**SUBJECT: FINAL TRIP REPORT—DECOMMISSIONING INSPECTION OF THE  
HOMESTAKE MINING COMPANY OF CALIFORNIA, GRANTS, NEW  
MEXICO (RFTA NO. 96-16)**

**TRIP REPORT  
DECOMMISSIONING INSPECTION OF THE  
HOMESTAKE MINING COMPANY OF CALIFORNIA  
GRANTS, NEW MEXICO**

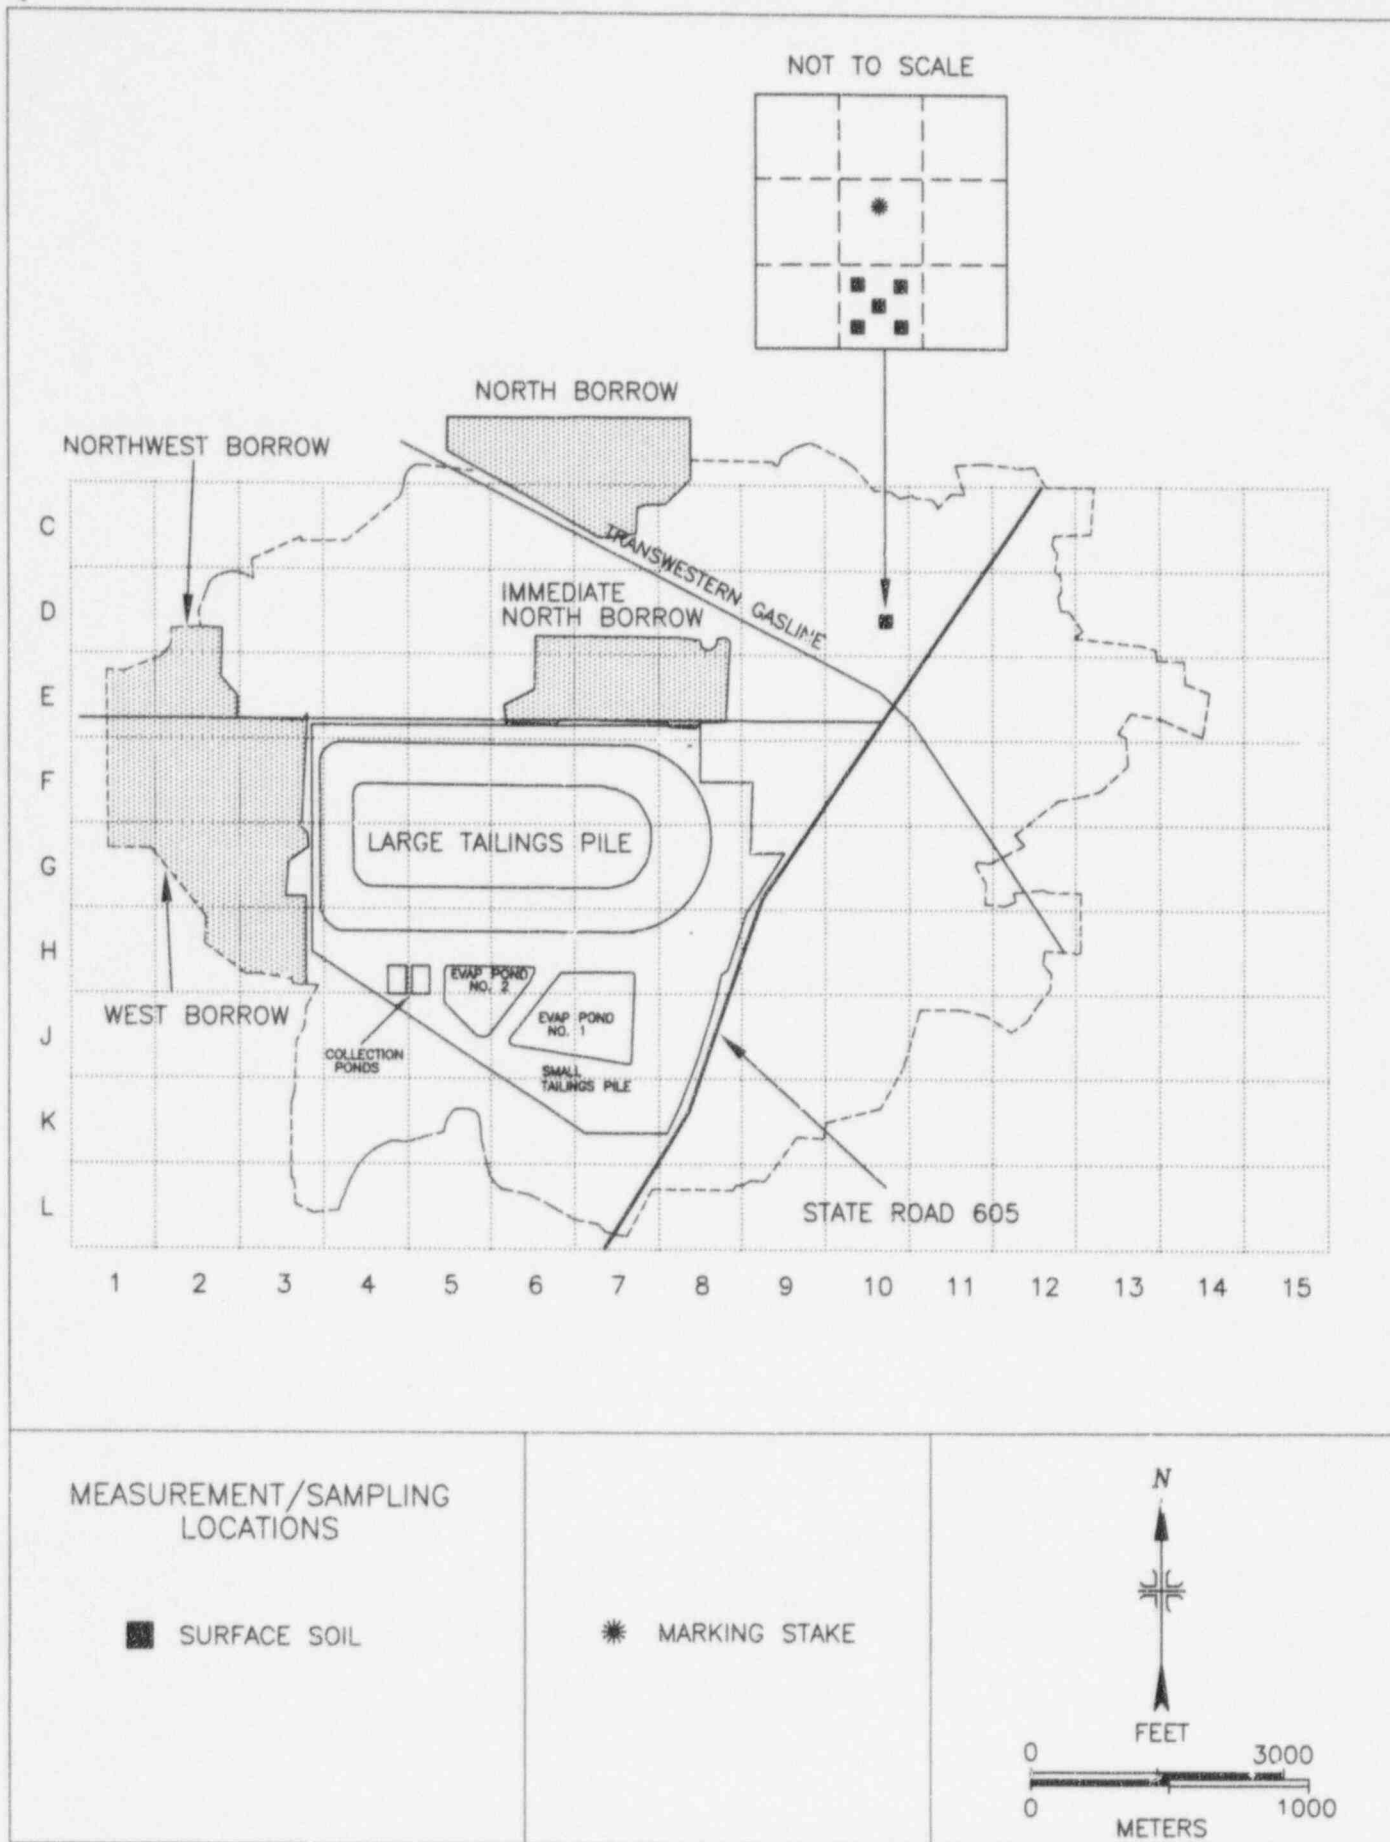
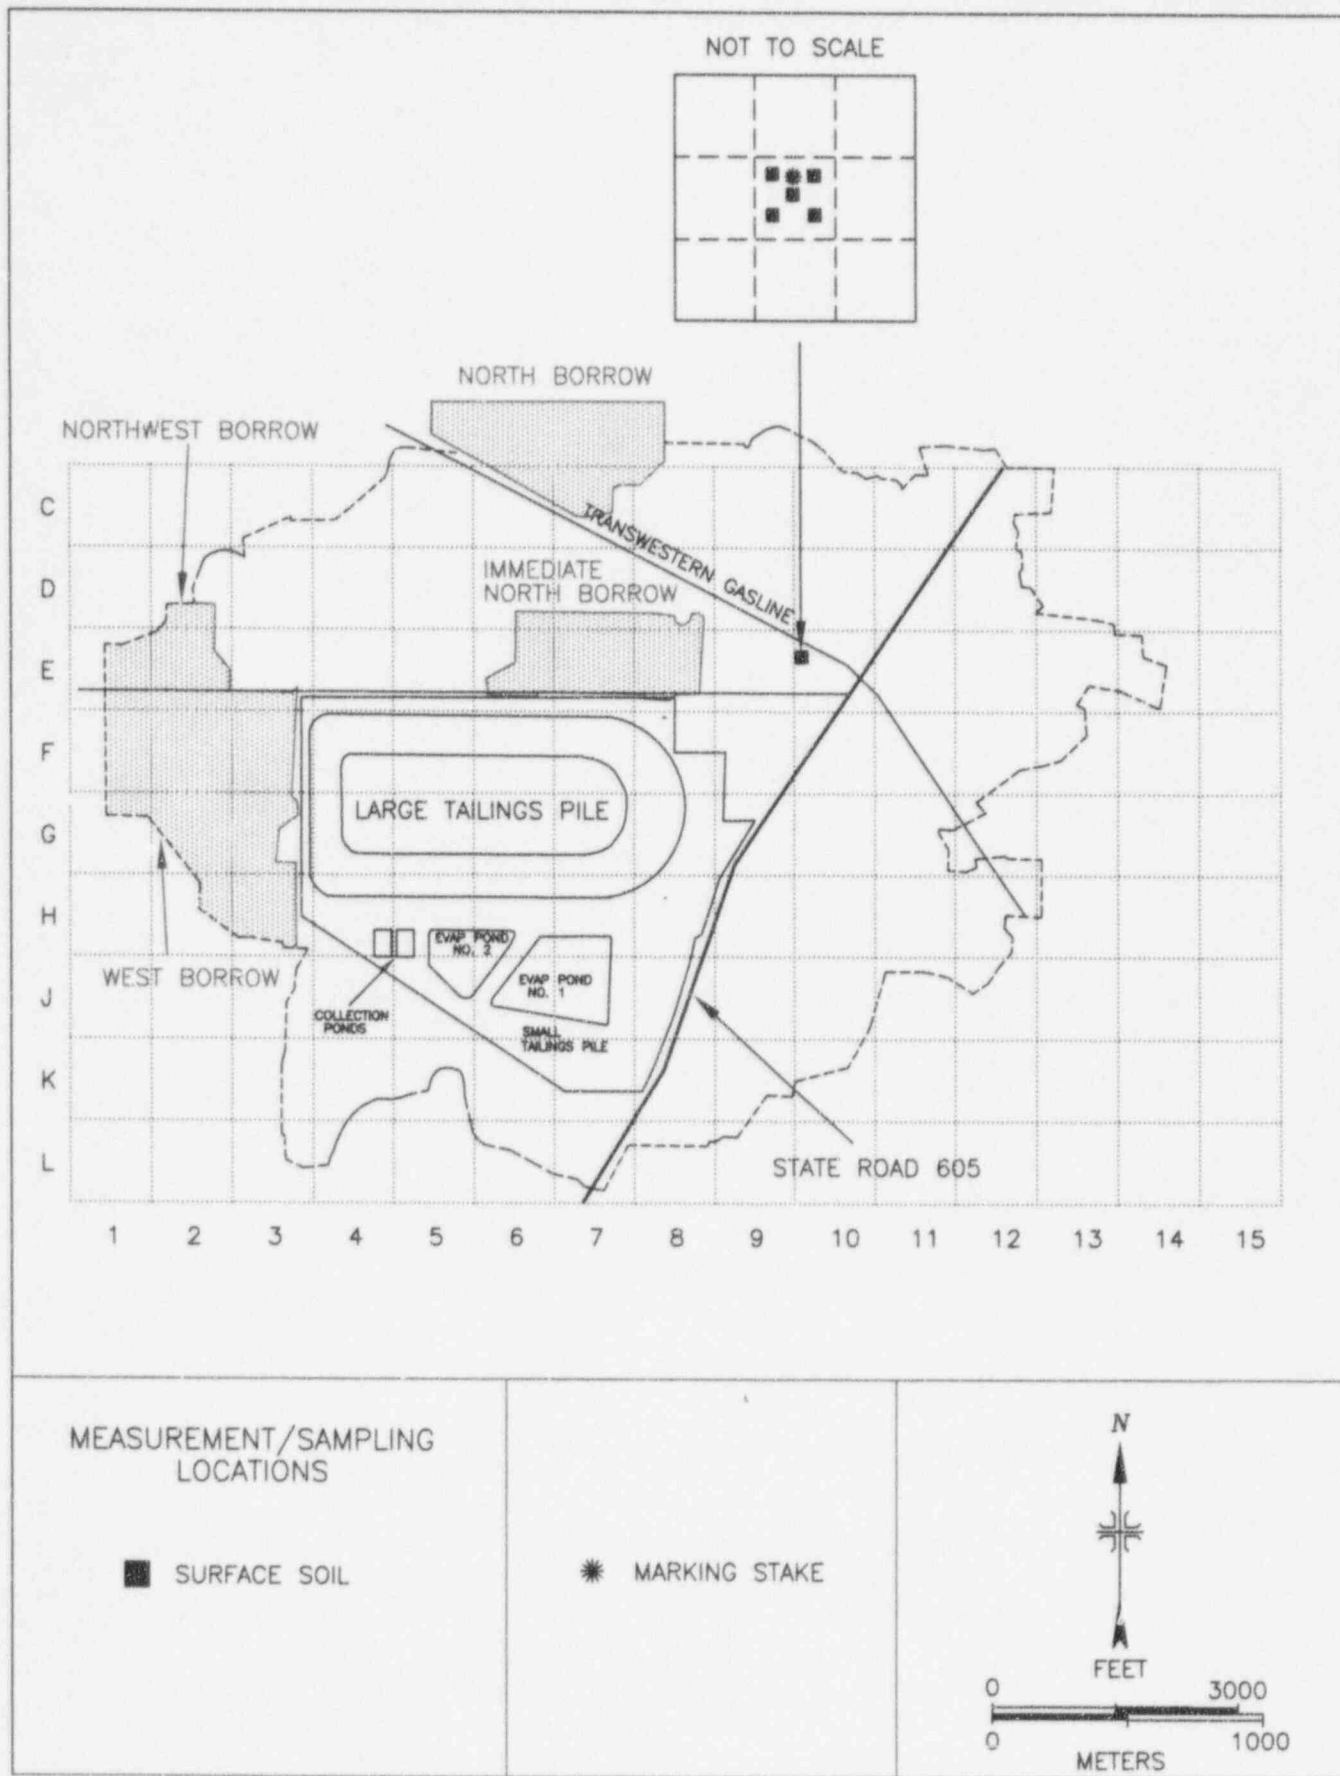
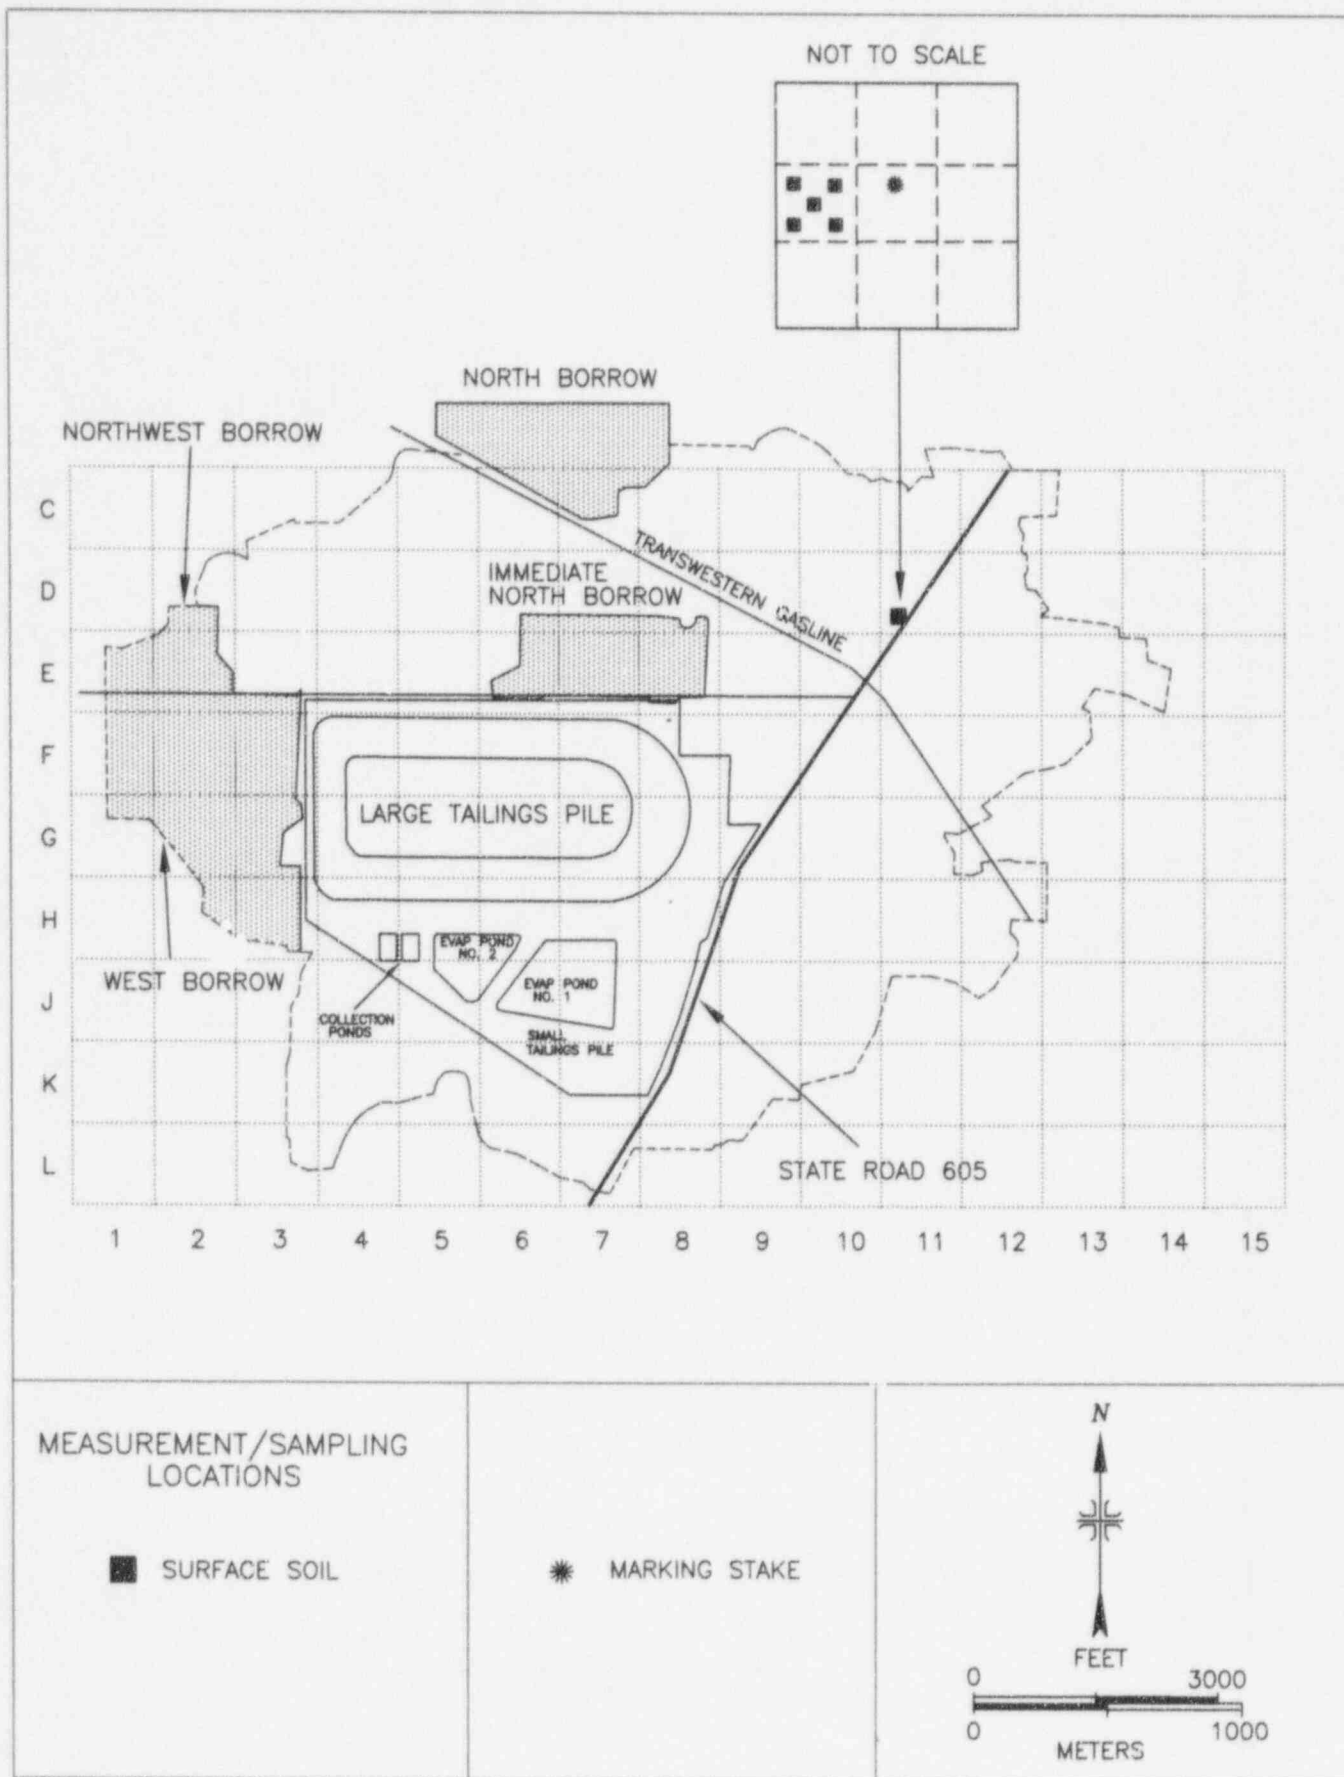
- 6.4 Perform gamma readings with a  $\mu$ R meter at random and suspect locations, in windblown areas and on cell covers.
- ESSAP performed gamma surface scans over seven 900 m<sup>2</sup> areas—selected on the basis of the licensee's data indicating potential anomalies—within the Outer Zone (Figures 1 through 9) and seven areas within the buffer zone and  $\mu$ R/h measurements were performed at 40 locations within the Outer Zone. These measurements are provided in Table 1. No measurements were made on the pile covers.

Gamma scans identified a number of locations of elevated direct radiation within surveyed areas from which ESSAP collected composite samples from the 100 m<sup>2</sup> area associated with each anomaly (a total of eight samples were collected from the seven surveyed areas). These samples were processed by the licensee and split samples prepared for confirmatory gamma spectrometry analysis by the licensee and ESSAP. The licensee was requested to collect a sample from an eighth area identified within the buffer zone. An additional sample was collected by the licensee and provided to ESSAP for analysis on November 7, 1996.
